Work Order ID 103517

Item Name: Aft Crosstube

DRAWING NO. REV. F  
D407-667-245 SHEET 1 OF 4  
TITLE SCALE  
CROSSTUBE ASS'Y (407 HIGH AFT) NTS

DRAWING NO. D407-667-245	TITLE CROSSTUBE ASSY (407 HIGH AFT)	REV. F	DART AEROSPACE LTD ENGINEERING ORDER		D.E.O. NO. D407-667-245-F-1	SHEET NO. SHEET 1 OF 2	SCALE NTS
DRAWN	CHECKED	MFG. APPR.	APPROVED	DE APPR.			
DATE 11.04.08	DATE 11.04.12	DATE 11.04.12	DATE 11.04.12	DATE 11.04.12	DATE 11.04.12

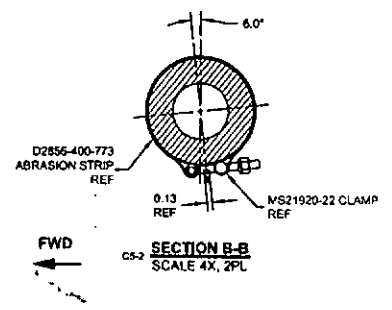
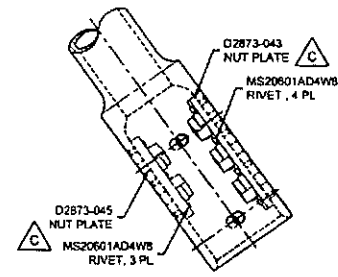
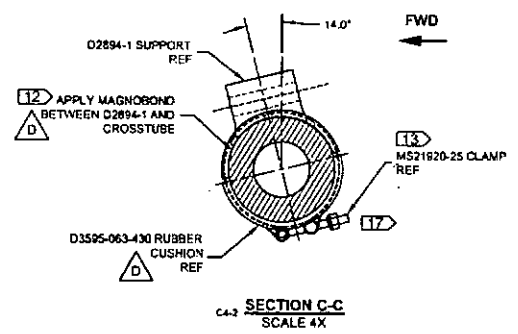
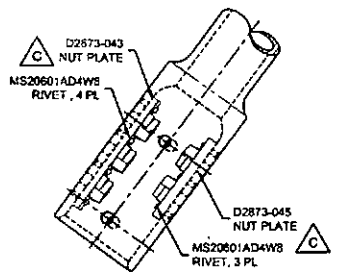
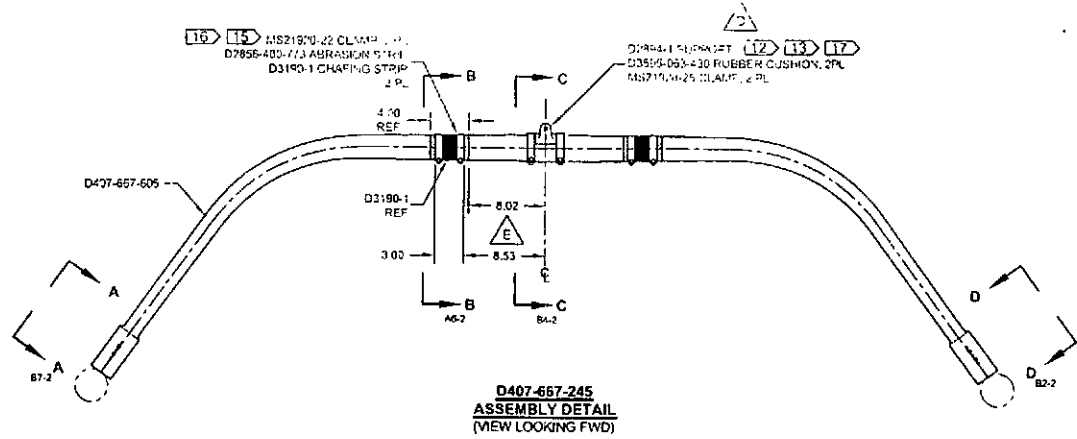
F	REFORMAT NOTES TO NEW STANDARDS (ZN B8-1); RELOCATED FLAG # 5 (ZN A8-3) PER NCR 210; REMOVED REF. & ADD TOLERANCES (ZN C6-3, C4-3 & D2-3)	RF	08.11.06
E	8.02 AND 8.53 WERE 8.40 AND 8.90 (ZN D5-2); REORGANIZED VIEWS AND REFORMATED DRAWING TO CURRENT STANDARDS. REASONS: CLAMPS MOVED 0.375 TOWARD CL TO ELIMINATE INTERFERENCE WITH AIRCRAFT MOUNTS. REFERENCE: PAR#08-21 AND EGM#1225	MB	08.07.24
D	ADD VIEW FOR OEM SKID HOLES, ROTATE ORIENTATION OF CLAMPS SECTION F-F, REMOVE -851 ABRASION STRIP, ADD MAGNOBOND 6398, ADD CUSHION	PH	07.02.07
C	ADD HOLES AND NUT PLATES FOR COMPATIBILITY WITH BHT/AA SKIDTUBES	PH	05.07.26
B	ADD CHAFING SHIELD	CP	03.05.21
A	NEW ISSUE	CP	02.05.13
REV.	DESCRIPTION	BY	DATE
DESIGN	97		
DRAWN	RF		
CHECKED	CP		
MFG. APPR.	97		
APPROVED	97		
DE APPR.	97		
DATE	08.11.06

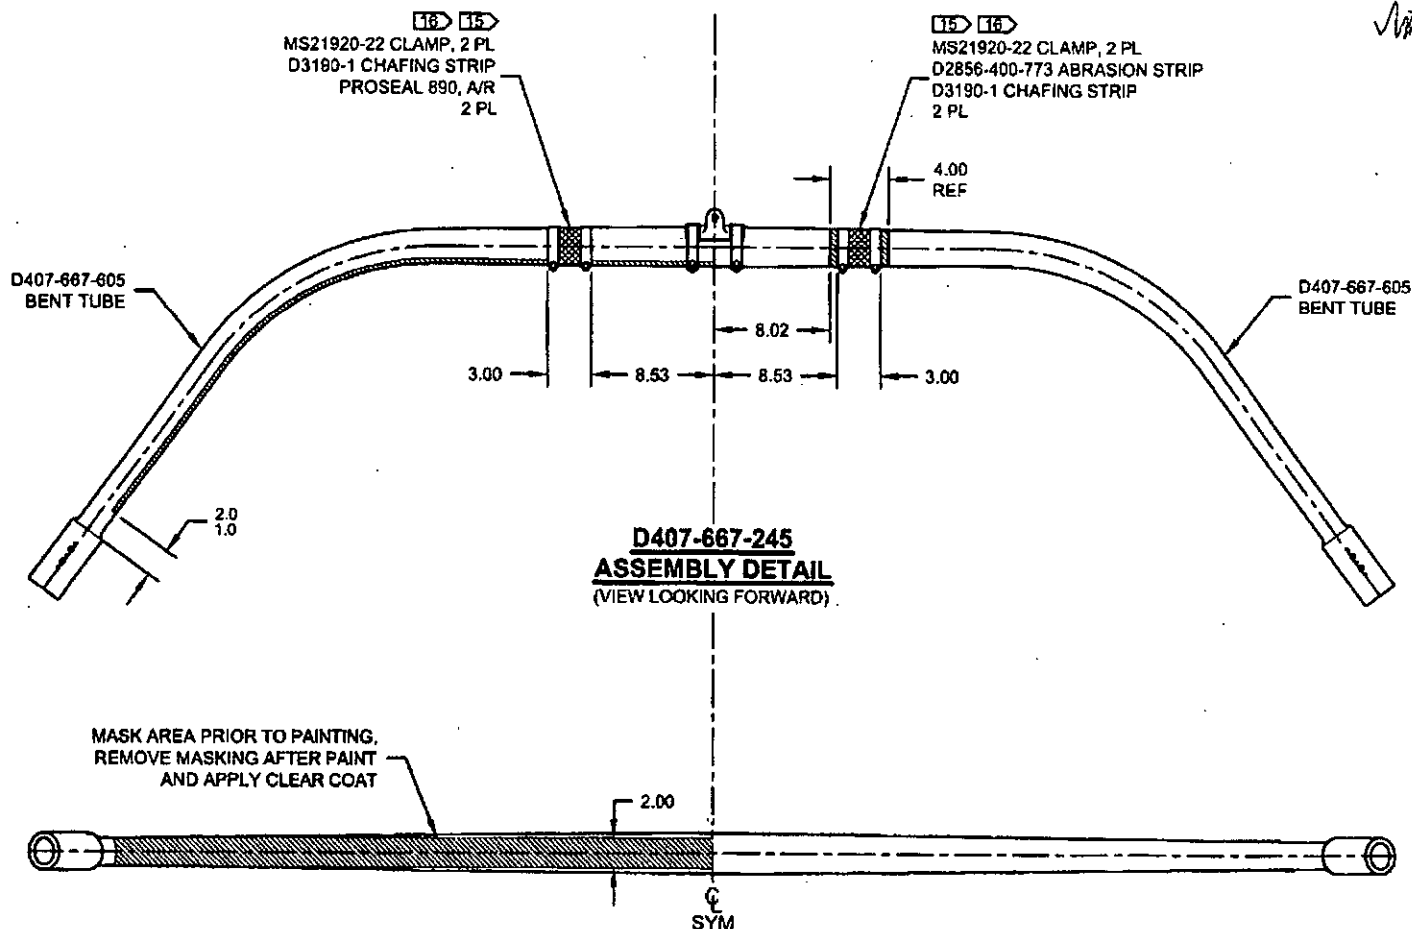
NOTES 2 AND 15, SHEET 1 ARE AMENDED AS FOLLOWS:

- 2) FINISH: CHEMICAL CONVERSION COAT PER DART QSI 005 4.1  
PRIME INSIDE AND OUTSIDE PER DART QSI 005 4.2  
MASK UNDERSIDE OF CROSSTUBE AS SHOWN (HATCHED AREA) AND  
PAINT OUTSIDE PER DART QSI 005 4.2  
REMOVE MASKING AND APPLY CLEAR COAT
- 15) APPLY A THIN COAT OF PROSEAL 890 ON INSIDE CONCAVE SURFACE OF D3190-1  
CHAFING SHIELDS AND LET CURE PER MANUFACTURER'S INSTRUCTIONS. INSTALL  
PROSEAL D3190-1 CHAFING SHIELDS ONTO CROSSTUBE BY APPLYING A THIN COAT  
OF PROSEAL 890 ONTO CROSSTUBE. BE SURE TO ELIMINATE ANY AIR GAPS.

- 2) FINISH: CHEMICAL CONVERSION COAT PER DART QSI 005 4.1  
PRIME INSIDE AND OUTSIDE PER DART QSI 005 4.2  
PAINT OUTSIDE PER DART QSI 005 4.2
- 15) INSTALL D2856-400-773 ABRASION STRIP WITH A 0.13 REF GAP ON BOTTOM SIDE OF  
CROSSTUBE PER QSI 035.
